Barangaroo Concept Plan Modification MP06_0162 Mod 4

Barangaroo South (Hotel development, additional GFA and Height)
SEPP (Major Projects) 2005 proposed amendment

Submission to the NSW Department of Planning 24 September 2010

Figure 4. Suggested sub-staging of Barangaroo South to enable progressive approvals

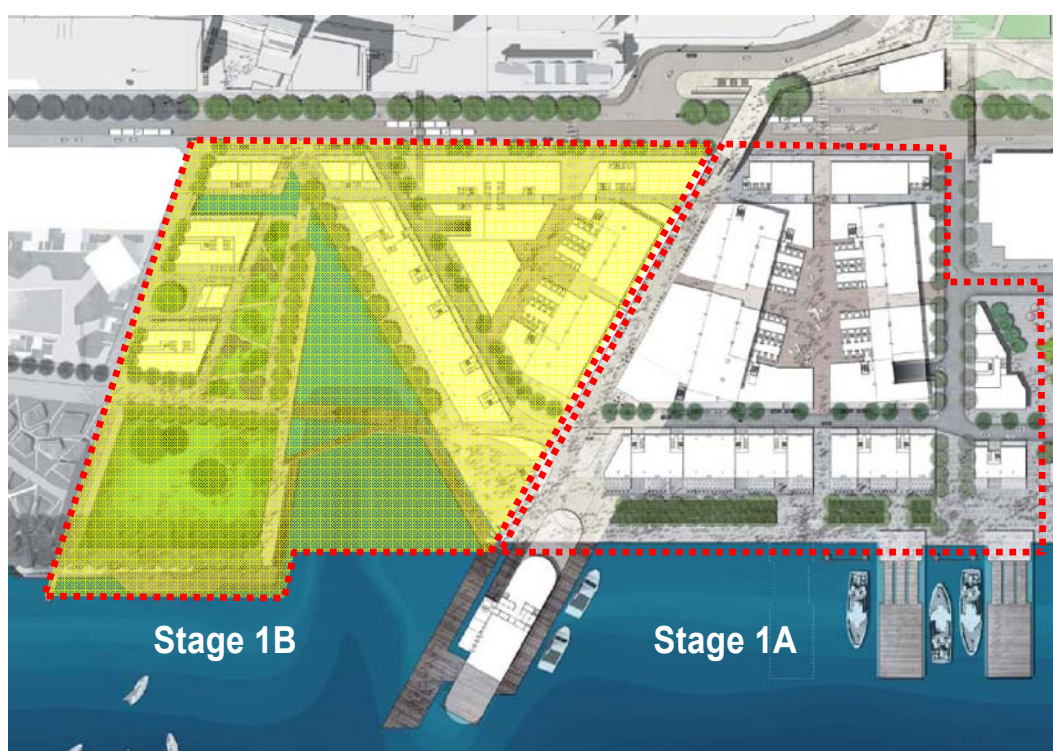
Without substantial amendments as set out in this submission, the City of Sydney is strongly opposed to the proposed modification to the currently approved Concept Plan. If the application is conditionally approved in part, then for the purposes of determining the application, it is recommended that the application be divided into two sub-stages 1A and 1B, and that the development contained in those sub-stages be determined and deferred as follows (refer Figure 4):

- southern half of Stage 1 (referred to as Stage 1A by the City) be potentially approved but only subject to conditions which remove the tower/pier hotel use and

Block Y; amend the building designs, amend the quantum of GFA and improve and protect the public domain; and

- northern half of Stage 1 (referred to as Stage 1B by the City) be separated out and deferred, and that the Proponent be required to respond to directions for design amendments including (but not limited to) the removal of the tower/pier and relocation of the hotel, removal of the northern residential towers, increased separation between towers (and preserving the Grosvenor Street view corridor), amending building heights, remodelled building designs, adding more affordable housing in Hickson Road (C1), amend the quantum of GFA, retention of the canal (including its connection to Barangaroo Central) and other improvements to protect the public domain.

Figure 10. Indicative Maximum Building Height, Location and Dimension Map p.43 of the Rogers Stirk Harbour + Partners Urban Design Statement. Figure 11. (below) Block Y Envelope

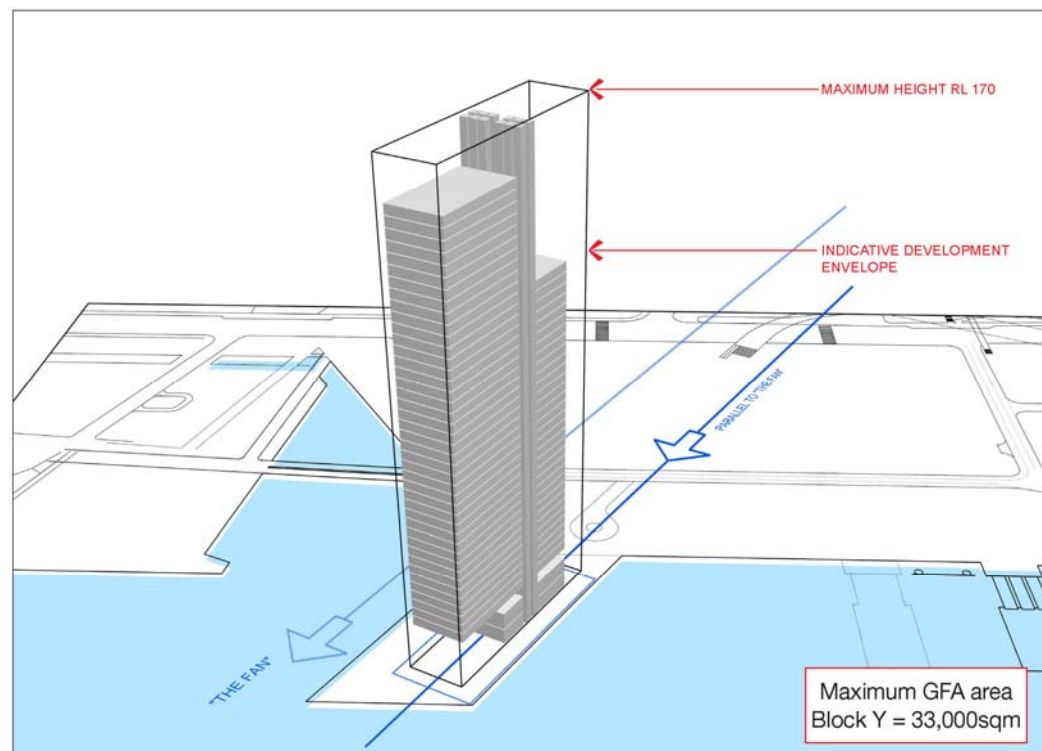
The following diagrammatic building mass for Block Y, for example, demonstrates this issue (which states Maximum GFA 33,000m²):

The building is shown to have a height of RL 170 with a length of 80 metres and a width of 25 metres (a potential floor plate of 2000m²). This disparity means the building with a maximum GFA of 33,000m² might only reach a height of approximately 20 storeys (+ the lobby/restaurant/function space on the ground floor + lift overruns) depending on final design, whereas the Development Envelope seeks flexibility for twice this height.

Figure 13. Concept Plan Amendment Application: “Indicative Maximum Building Height, Location and Dimension Map” Rogers Stirk Harbour + Partners *Urban Design Statement* p. 43

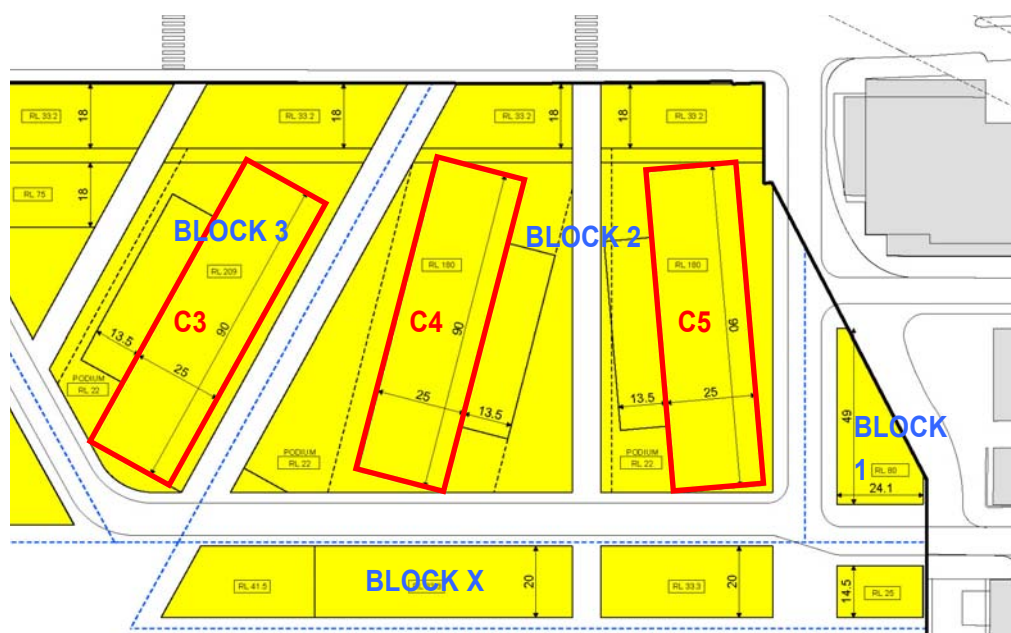
The proposed envelopes and controls allow the towers to extend up to 90m in length, as shown in the “Indicative Maximum Building Height, Location and Dimension Map” (Figure 10) and Block 2 and 3 envelope controls. Towers C4 and C5 have a maximum height of RL180 (indicatively shown at 40 storeys) and tower C3 has a maximum height of RL209 (indicatively shown at 50 storeys).

The bulk and scale arising from the combination of the proposed length and maximum height of the towers, together with the number of towers, gives rise to several urban design issues:

Figure 15. View from Maritime Museum – City of Sydney photomontage of Proponent’s concept outlines (scheme based on “Indicative Maximum Building Height, Location and Dimension Map” p.43 *Urban Design Statement*)

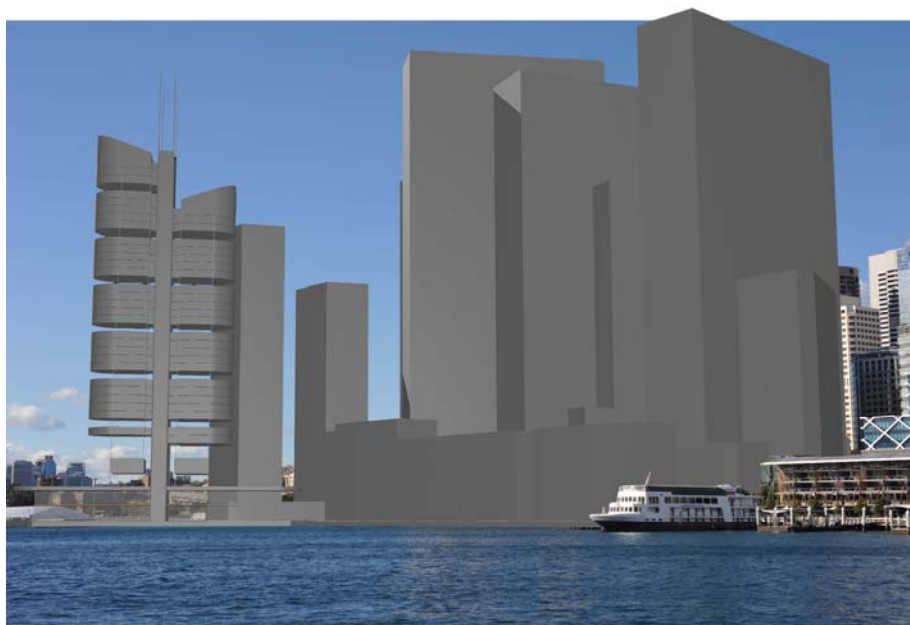
The combination of multiple towers at similar heights, with very long non-curved elevations creates a very large “wall” effect which is not consistent with the building morphology of the city. It precludes the low angle sky views between buildings that typify the Sydney skyline. As proposed, the towers would have an unprecedented and unreasonable visual impact, particularly when viewed from the south and south-west.

Figure 18. Façade Studies (Urban Design Statement p.95)

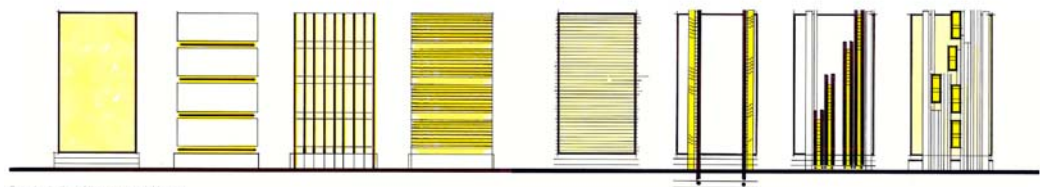
These approaches are generally supported; however they are not reflected in the proposed urban design controls. The urban design controls incorporated in the Concept Plan are not robust and clear enough ensure these outcomes will be achieved – particularly where buildings may be designed by different architects over a long period of time. In their current form, the urban design controls are inadequate. The controls do not clearly define desired outcomes and best practice urban design strategies to achieve the stated objectives; rather they are either too vague or overly specific with regard to architectural resolution, and lack clarity. An example of this is the proposed controls for Block 2 which read as follows:

Figure 21. Building heights – City recommendations

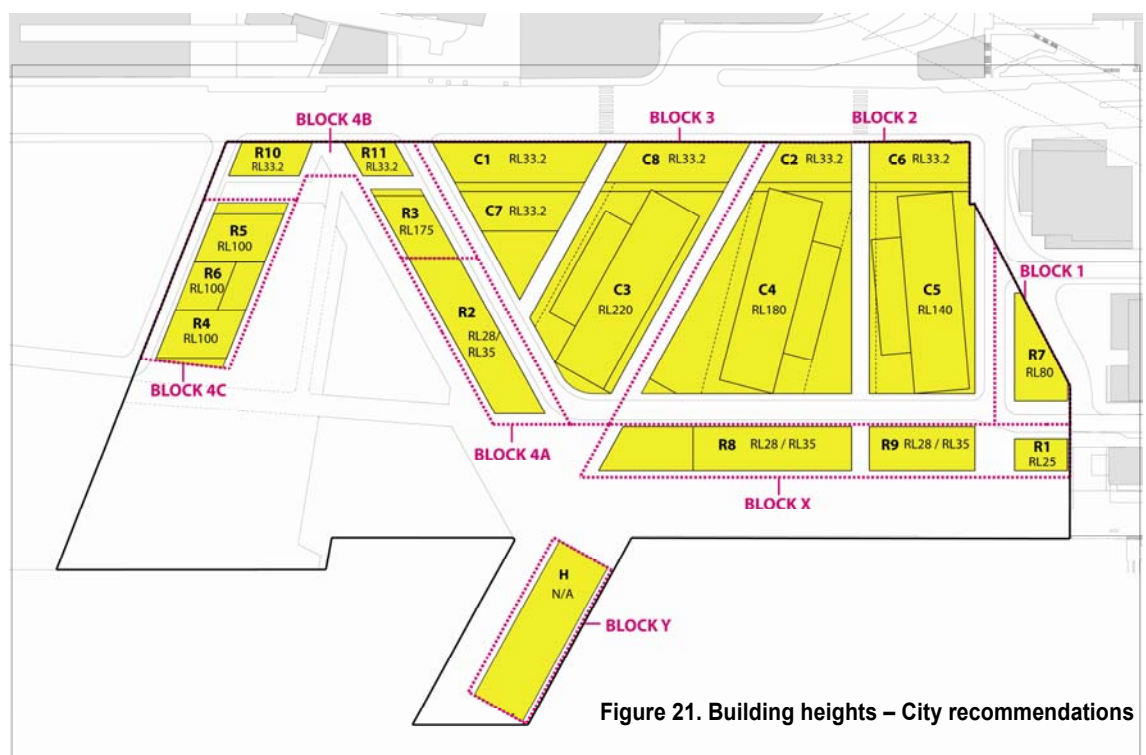
The concept plan modification seeks to vary maximum block heights across the site. The city's proposed changes, and urban design comments, are provided in Table 3:

Figure 33. Proponent's shadow diagrams + 'Public Places' (Streetscape & Public Domain Report)

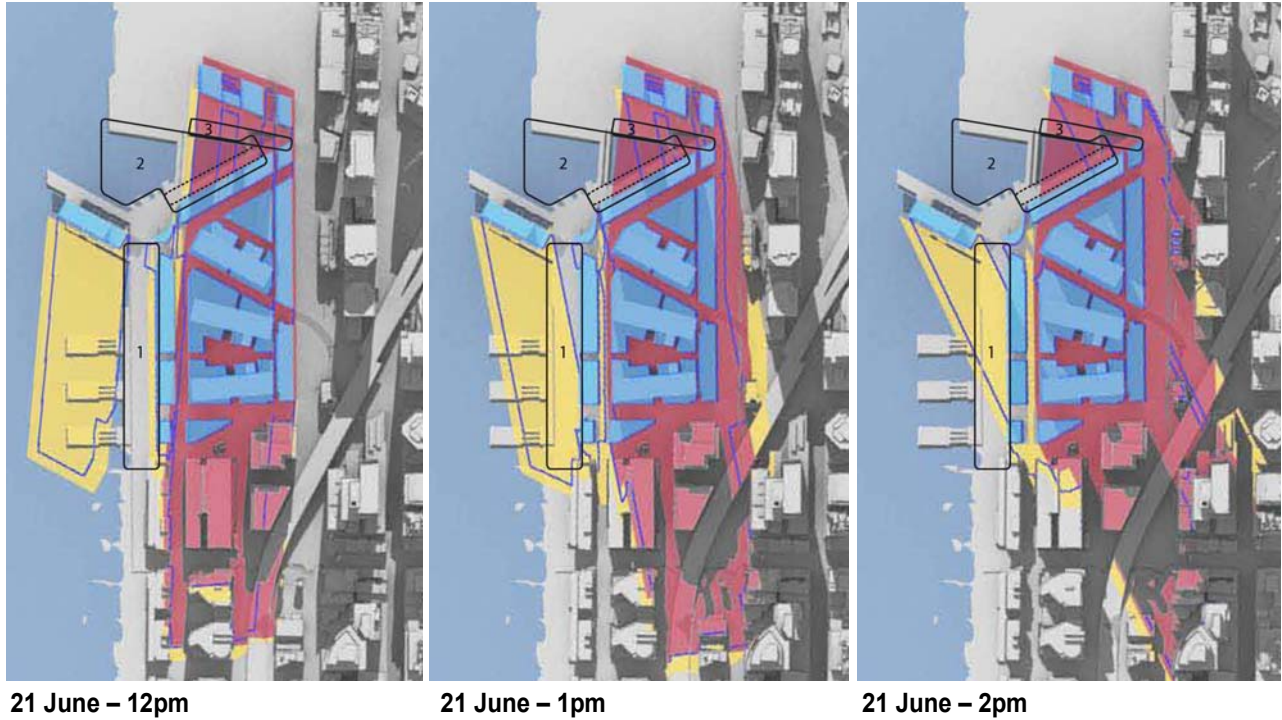
Table 4. Overshadowing factors

Figure 34. Approved Concept Plan
Street Hierarchy

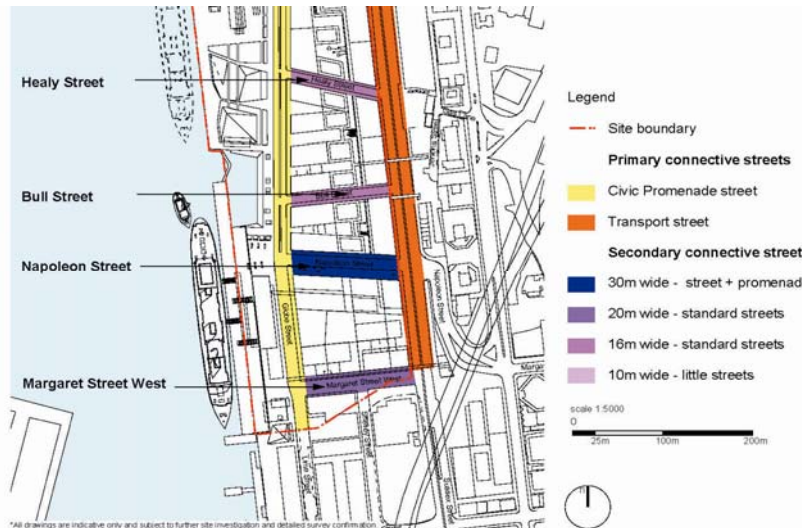
The proposal includes significant departures from the street hierarchy and structure approved under the Concept Plan, as shown below:

Figure 39. Indicative Design: Site Section AA *Urban Design Statement* p.112

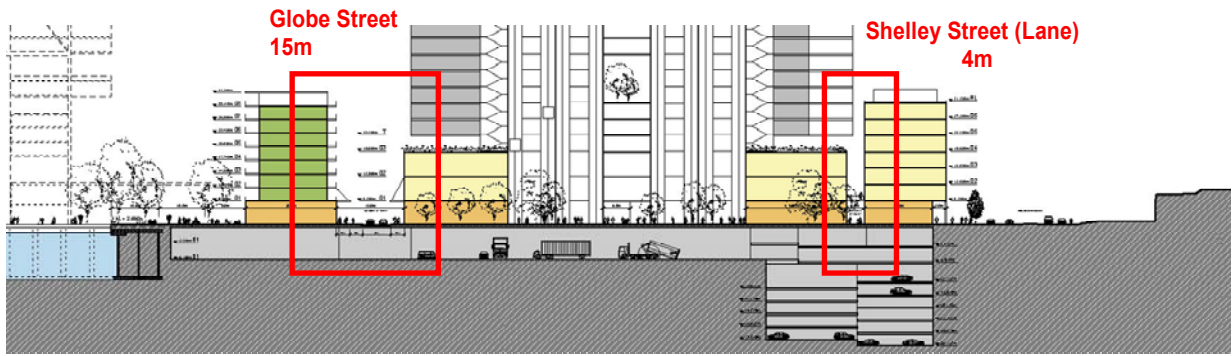
Several of these issues are illustrated well in the following indicative section:

Figure 41. Plan showing the preferred basement location and extent to preserve streetscape landscape

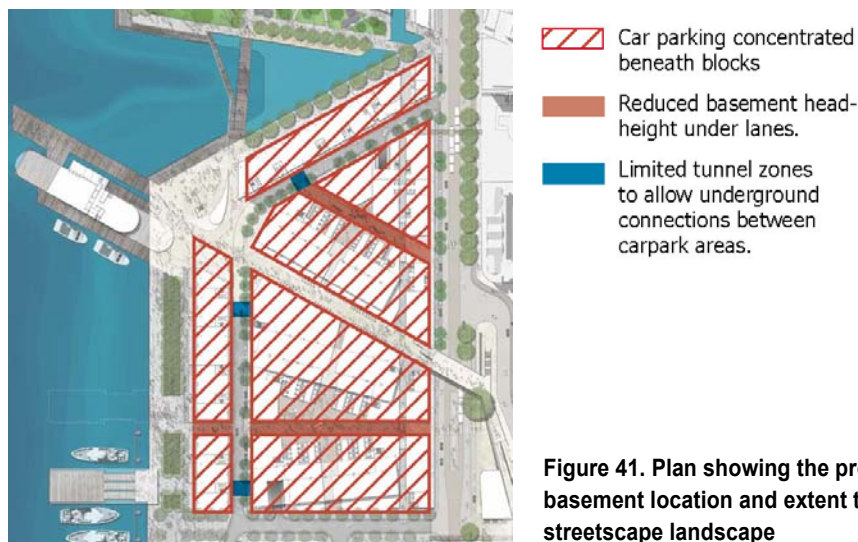
These concerns are reiterated in relation to this Concept Plan amendment application. Basement parking and truck servicing should be contained beneath blocks, with deep soil corridors retained along streets for services and planting of street trees now and in the future. Where connectivity beneath blocks (between basements) is desirable to minimize above ground vehicular circulation, tunnels may be provided connecting discrete basement areas. Tunnels should be set down beneath the finished ground level to provide a 1.5m minimum soil zone for services and tree planting, as illustrated below:
